## **STAFF REPORT**

**TO:** Planning Commission  
**FROM:** Nathan Fuerst, Consulting Planner  
Jenni Faulkner, Consulting Planner  
**AGENDA ITEM:** Wildflower Townhomes, Preliminary Plat/Planned Unit Development

Re: Wildflower Twinhomes PUD  
Preliminary Plat/Plan Review

# WILDFLOWER TWINHOMES PRELIMINARY PLAT

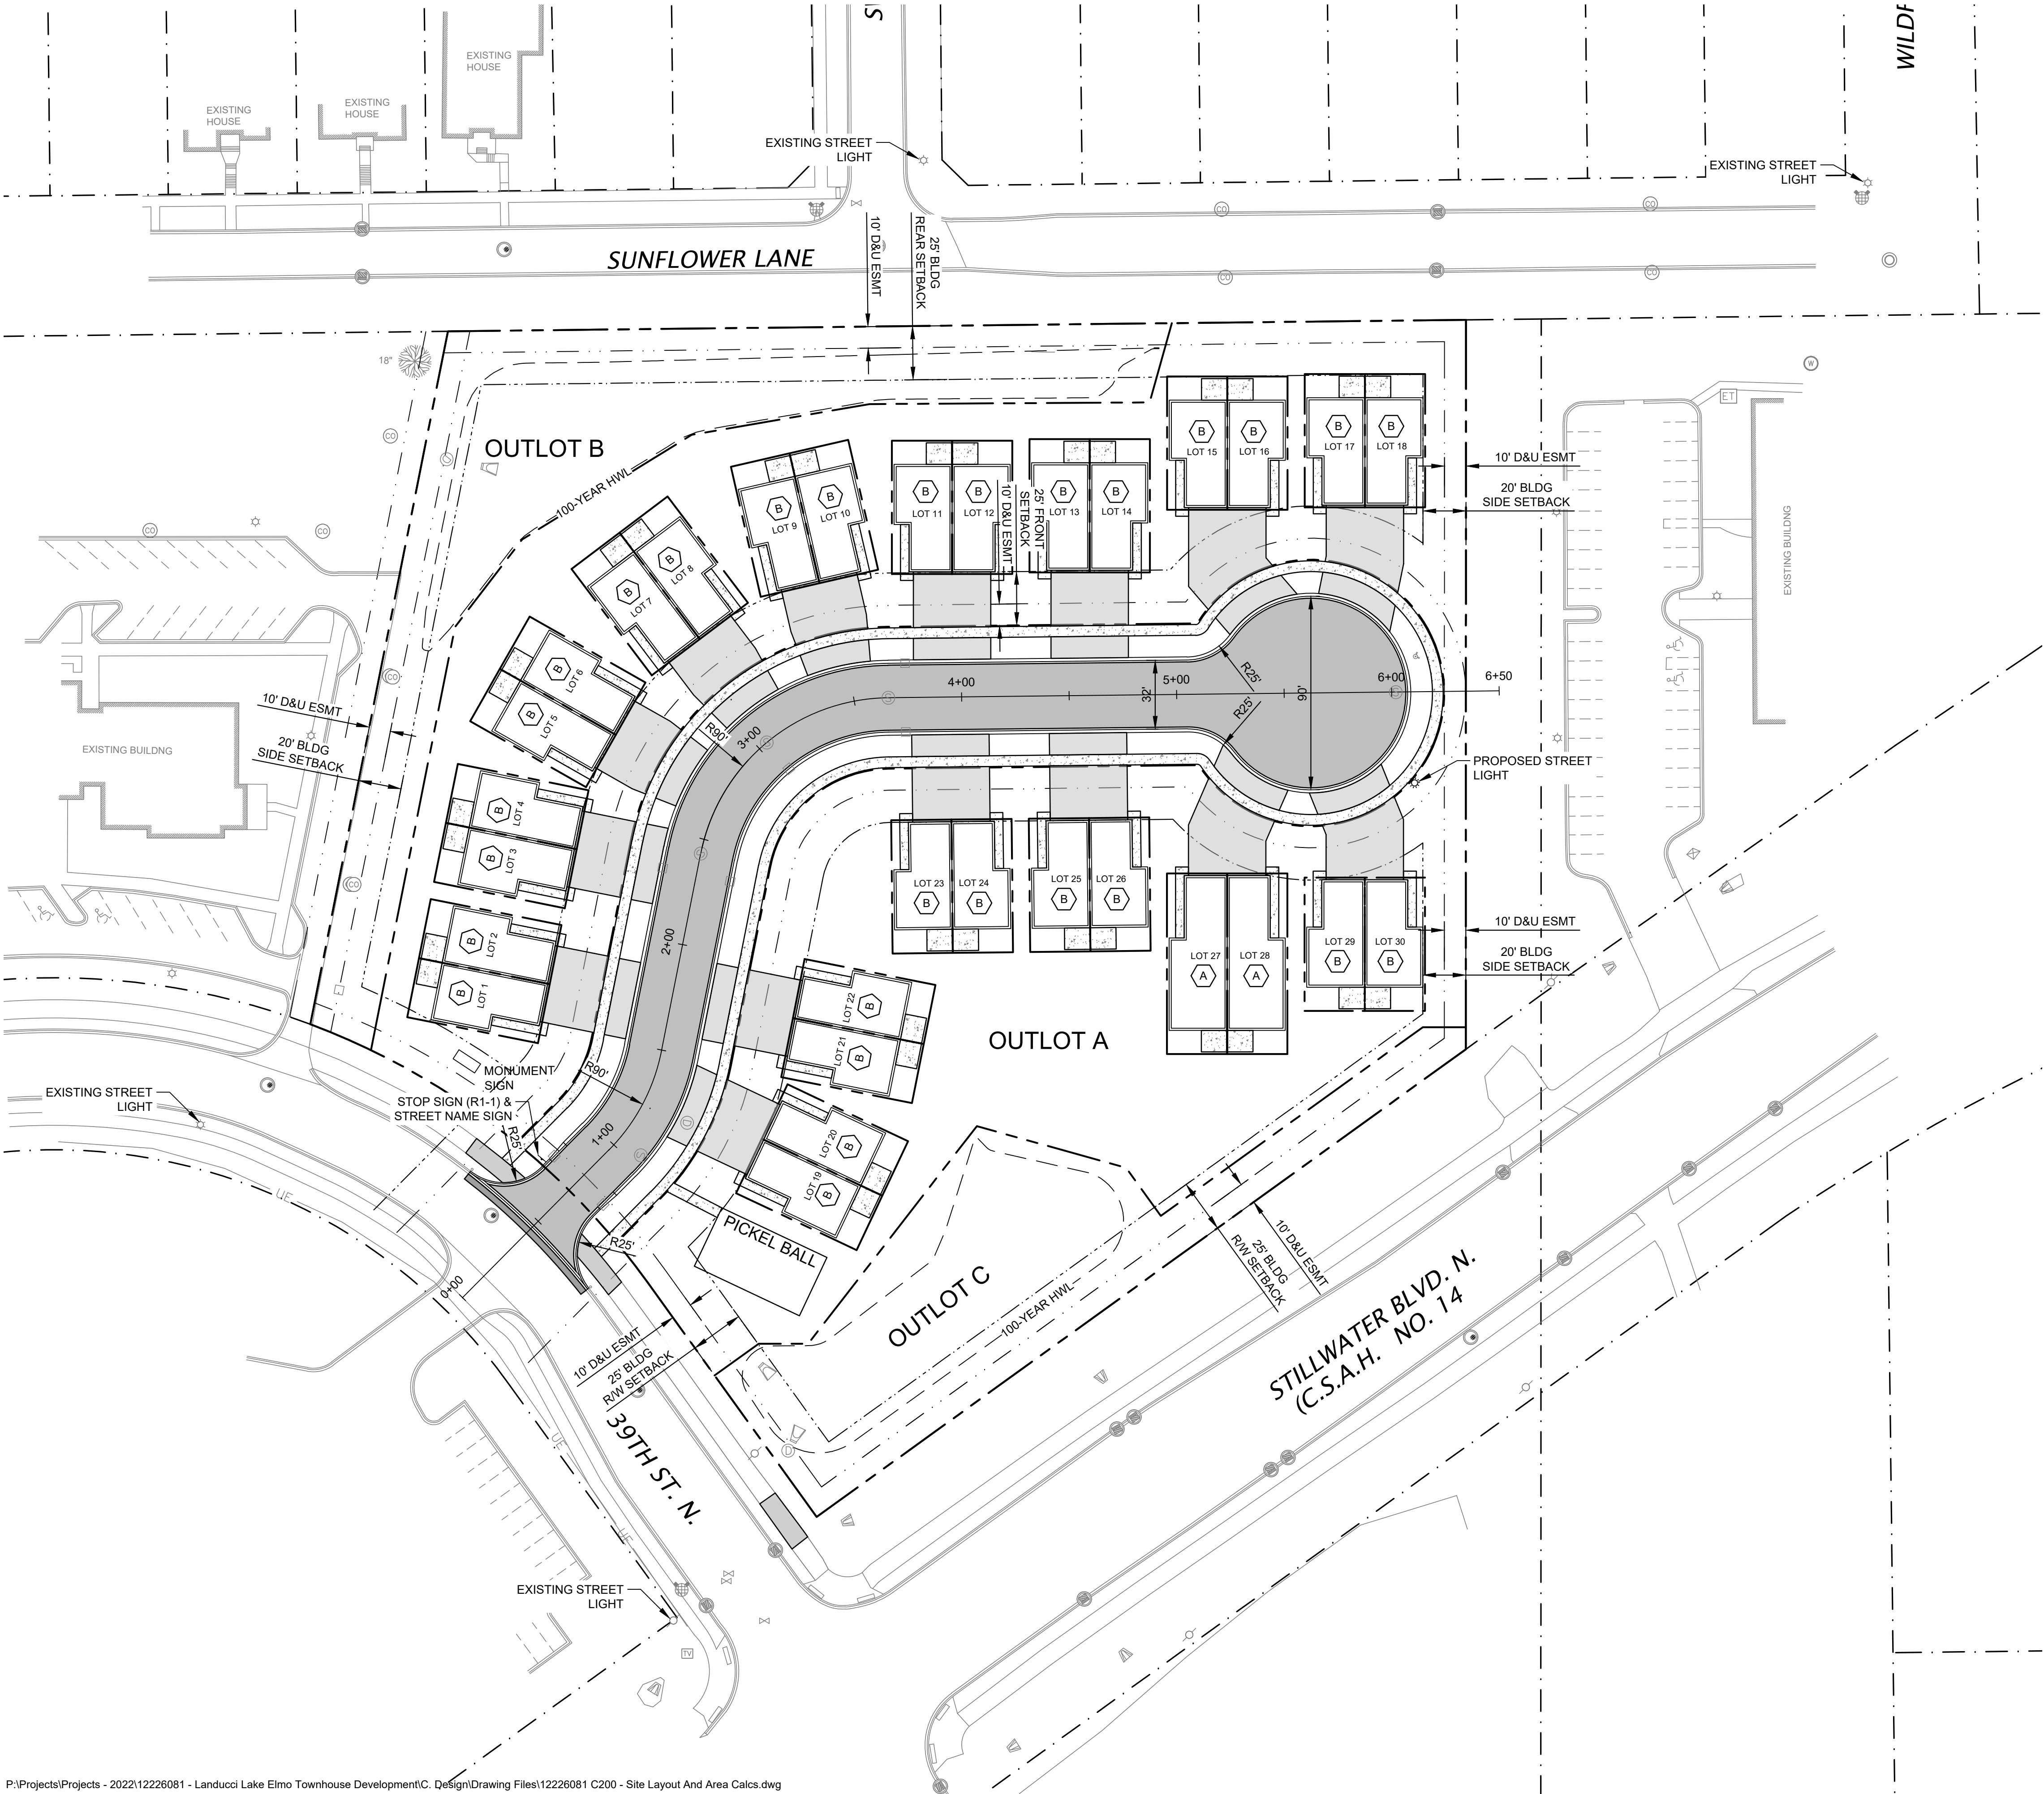
1. The Preliminary Plat and plans must be revised to show Outlot ownership and dedication. Outlot B and C should be shown as city owned for stormwater management basins. No drainage and utility easements should be shown over Outlots B and C. Outlot A should be shown as HOA owned.
2. Preliminary Plat approval must be contingent upon revisions to the Preliminary Plat as may be found necessary to dedicate additional right-of-way to accommodate any future County/City intersection improvements at Stillwater Boulevard and 39th Street.
3. Preliminary Plat approval must be contingent upon revisions to the Preliminary Plat as may be necessary to revise Outlot B and Outlot C to address to incorporate the 100-year HWL, 10-foot maintenance bench and all maintenance access roads; and to revise all building elevations as necessary to meet city and VBWD flood protection requirements.

4. The Preliminary Plat and Plans must be revised to show the building setbacks for Lots 1-15 to be 25 feet from the Outlot B property lines. Revisions to Lot 15 footprint will be required.

5. The Preliminary Plat and Plans must be revised to show all required Lot easements.
6. Phasing Plan. A condition of Preliminary and Final Plat approval must include the requirement to completion all utilities, stormwater management, street and sidewalk improvements including curb and gutter and the first lift of asphalt, sidewalks, and any off-site public improvements (if required) prior to issuance of any building permits. The development sequencing will be especially important for this very tight construction site and dead-end cul-de-sac.

PRELIMINARY  
SITE LAYOUT  
AND AREA CALCS

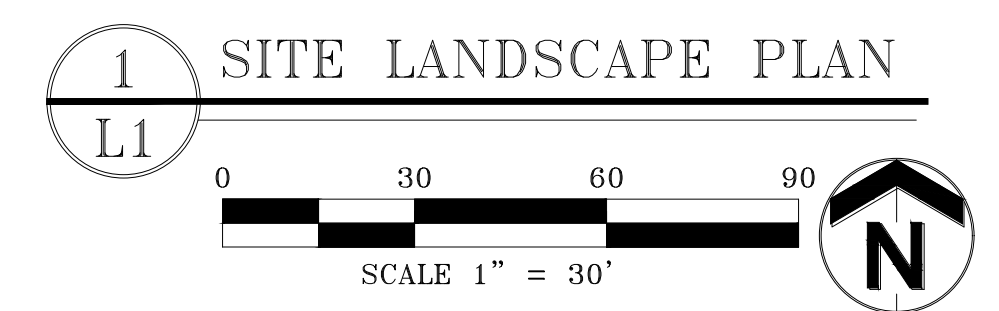
3. Site Access. Access to the proposed development is generally consistent with city requirements. The plans show a new public street extended approximately 600-feet in length from 39th Street North and terminates at a new cul-de-sac. The new public street has been shown to align with the existing commercial driveway for Lake Elmo Bank as required.

5. A public street is proposed in accordance with city design standards with a 32-ft wide street within a 66-ft right-of-way, and using the dimensions for a city standard cul-de-sac. The typical section must be revised to include all details per the city design standards including total right-of-way width, 10-ft drainage and utility easements on either side of the right-of-way, drainage easement grades, and the location of boulevard trees within the right-of-way.

LANDSCAPE PLAN  
TREES & GROUND COVER

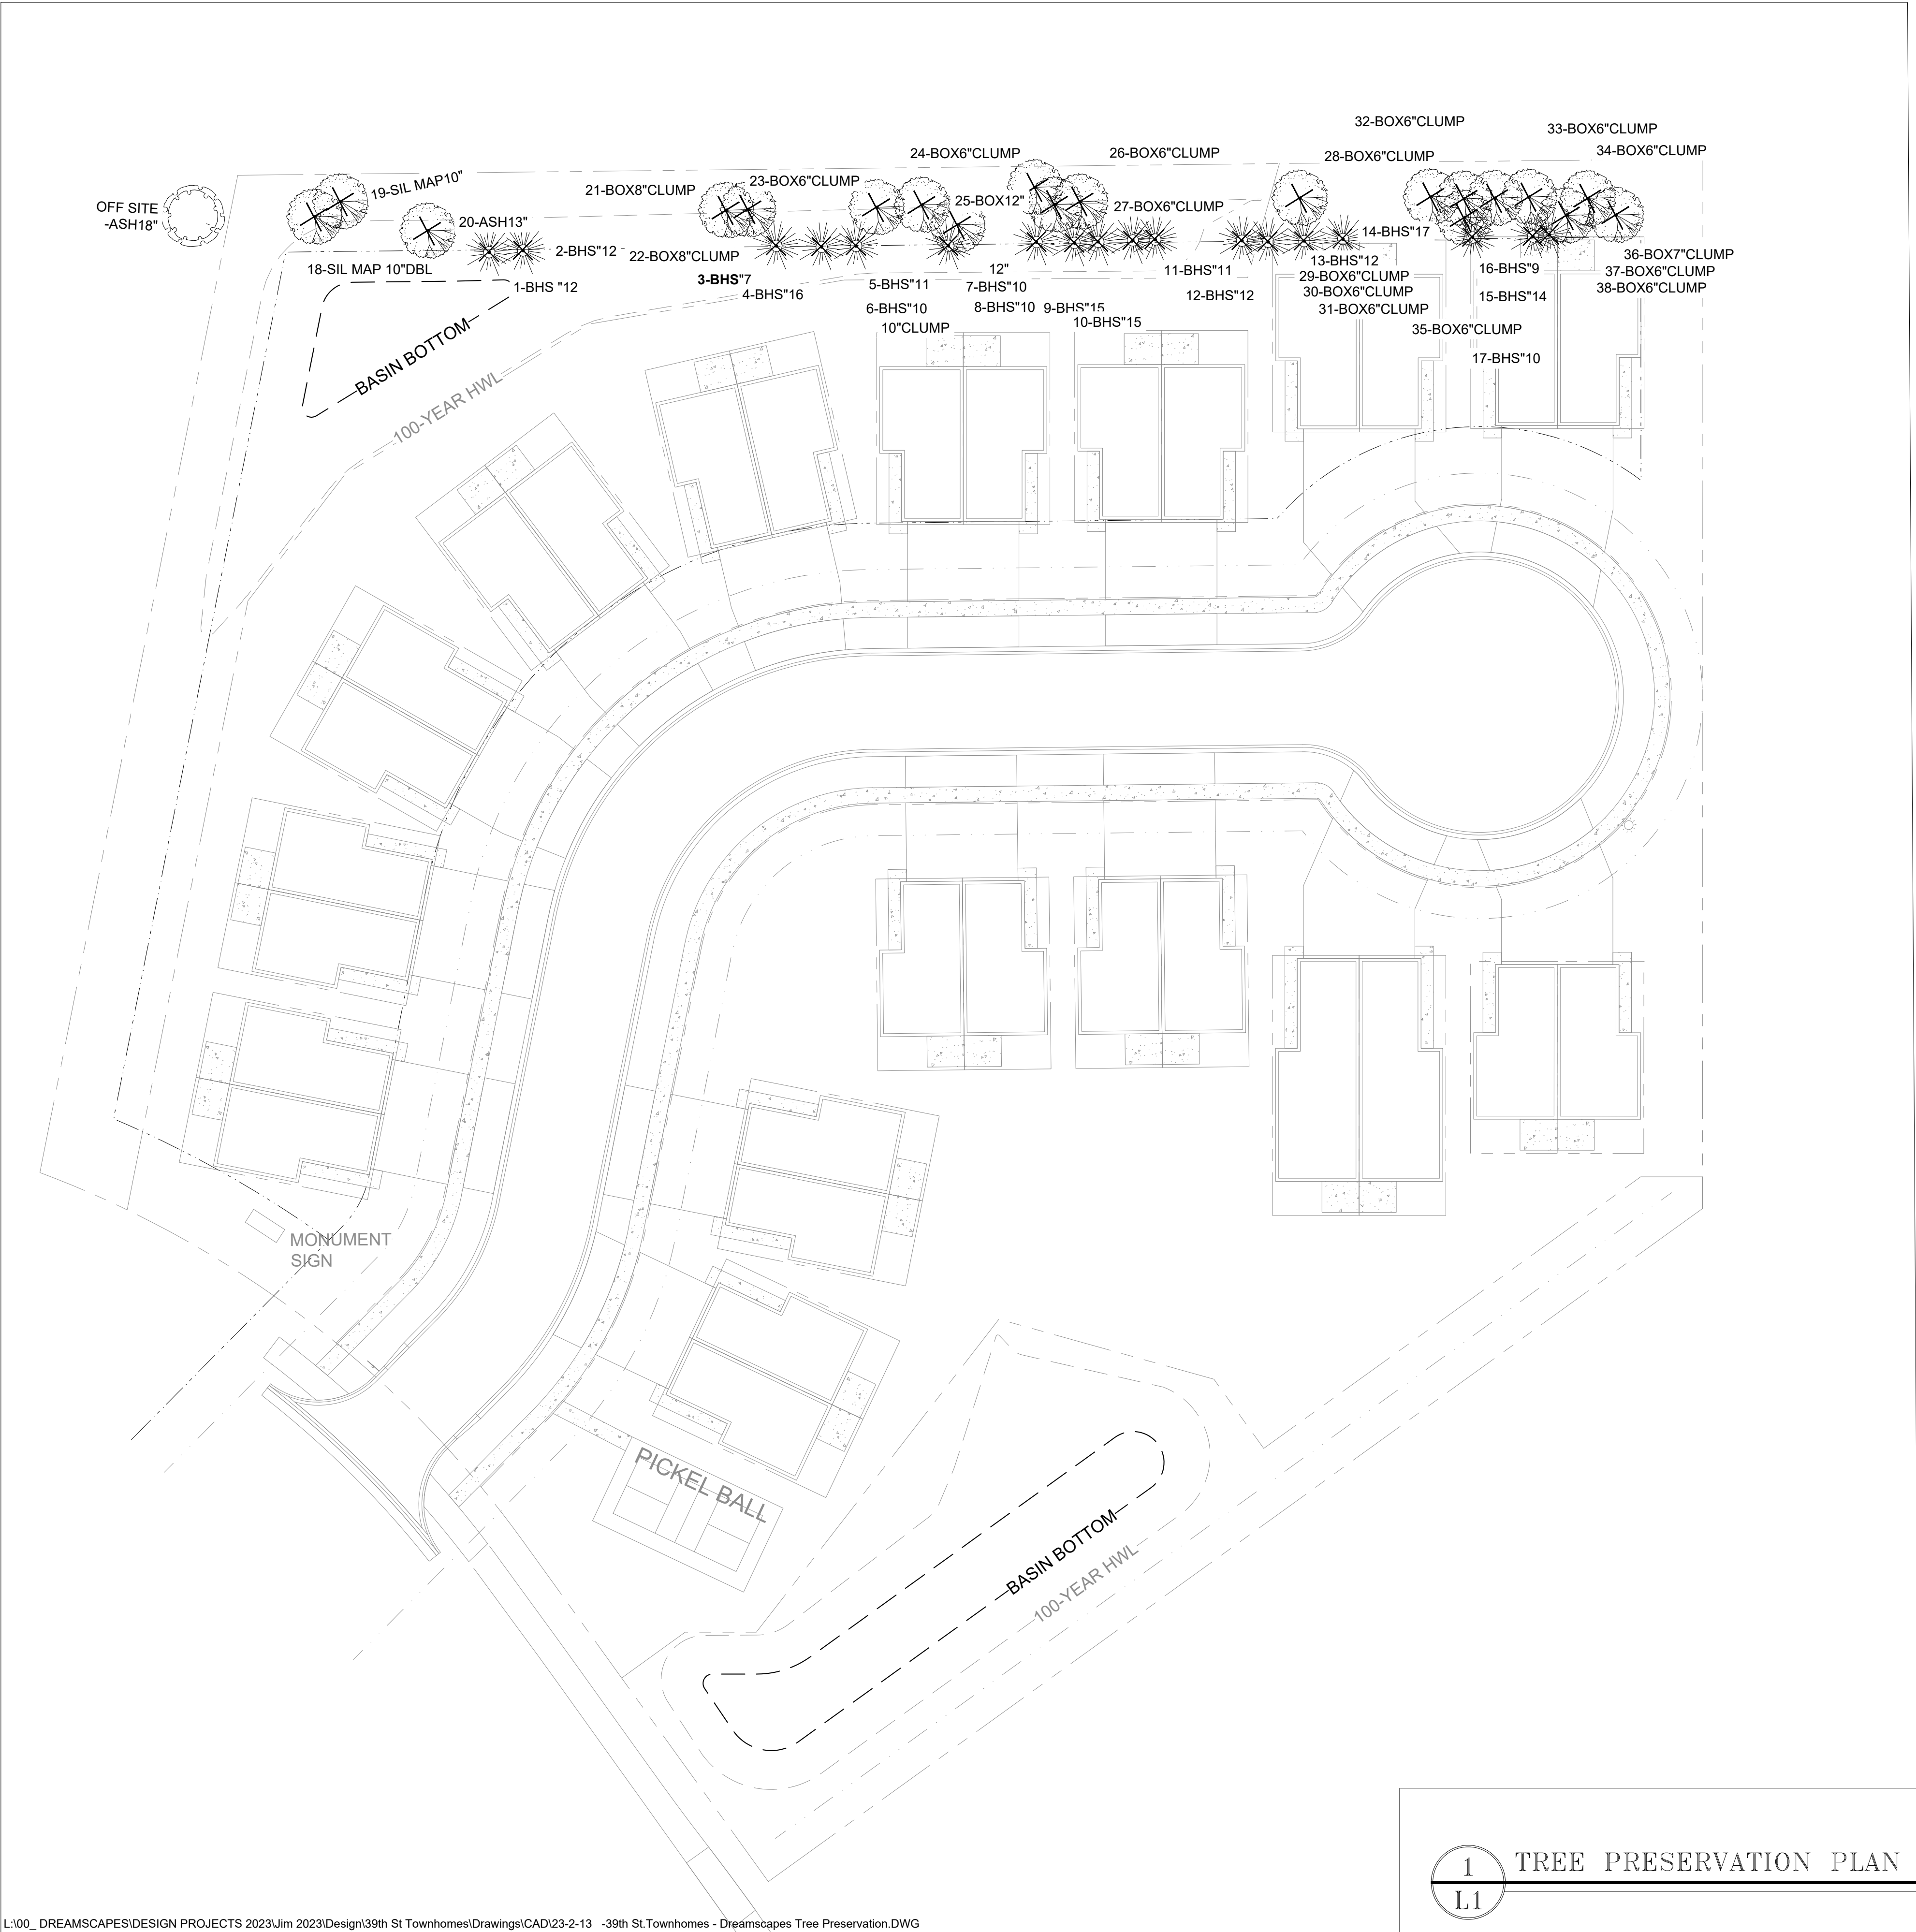
- The revised plans received do not include a tree planting plan; therefore, I cannot comment on whether proposed trees meet code requirements until such a plan is received. Per the previous memo, ensure their placement does not interfere with the required maintenance access route for the stormwater basins.
- Note that where ten or more replacement trees are required, not more than 30% of the replacement trees shall be the same species.
- Mitigation trees are in addition to all other required trees.

- The landscape plan will require the following adjustments in order to meet code:
  - Add Lake Elmo standard plan notes for landscape plans to one of the L sheets
  - Replace planting details with City of Lake Elmo standard details
  - An irrigation plan (or other provisions for watering) is required.
  - Ornamental trees are required to be 2" caliper.
  - Screening is required between different intensities of use, such as between the proposed twinhomes and existing single-family residential to the north of the site, and must be:
    - At least 6' in height and be 90% opaque year-round
    - A masonry wall or fence in combination with landscape material
    - 1 tree per 40 linear feet of property line
  - Details and cross sections of all required screening need to be added to the landscape plans.
  - The landscape plan will need to meet the required number of trees:

- Once the planting plan is adjusted to accommodate the required number of trees, the tree composition requirements will need to be met. Ensure that:
  - A minimum of 25% of proposed trees are evergreen
  - A minimum of 25% of proposed trees are deciduous shade trees
  - No more than 15% of proposed trees are ornamental
  - No more than 50% of the required number of trees or shrubs are any one species

- Label what the rectangular shapes in the entry sign planting bed are, either in the legend or via note.
- Notes from the prior sheet set that were not included in this revised set still apply:
